Technical Service Information

CHRYSLER JEEP AW4 2-3 FLAIR/REVERSE DELAY

Figure 1

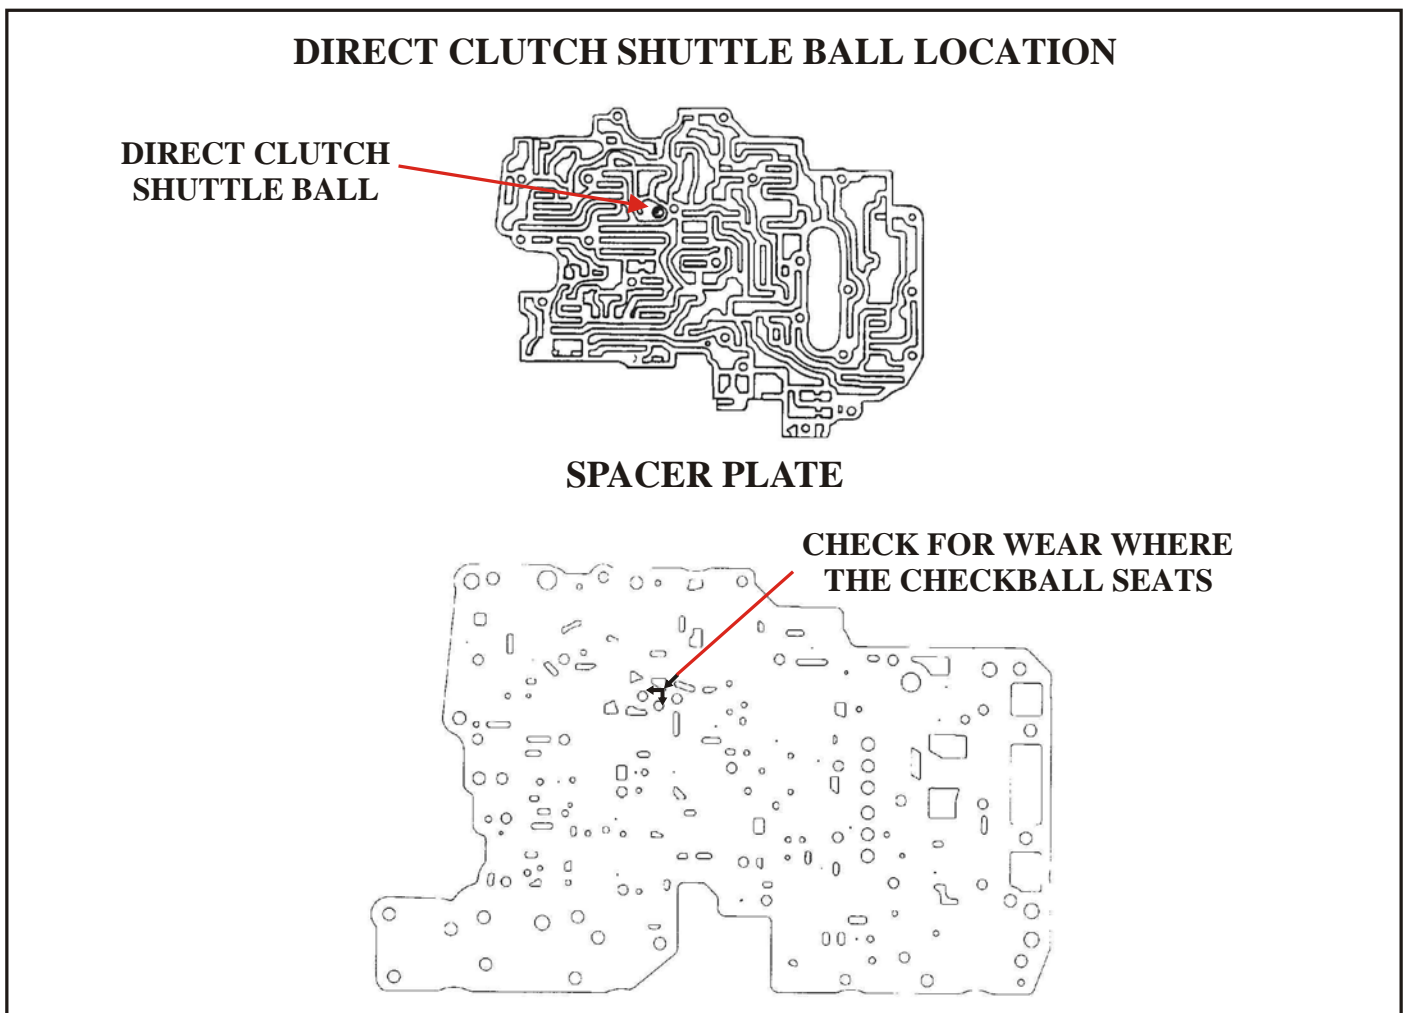
COMPLAINT: 1987-1989 Jeep vehicles equipped with AW4 transmissions may exhibit a flair on the 2-3 upshift or a delay on Reverse application.

CAUSE: The cause may be:
A worn spacer plate, where the direct clutch shuttle ball seats, causing a loss of direct clutch pressure. (See Figure 1)

CORRECTION: Replace the spacer plate.

SPACER PLATE PART NUMBER.....83503770
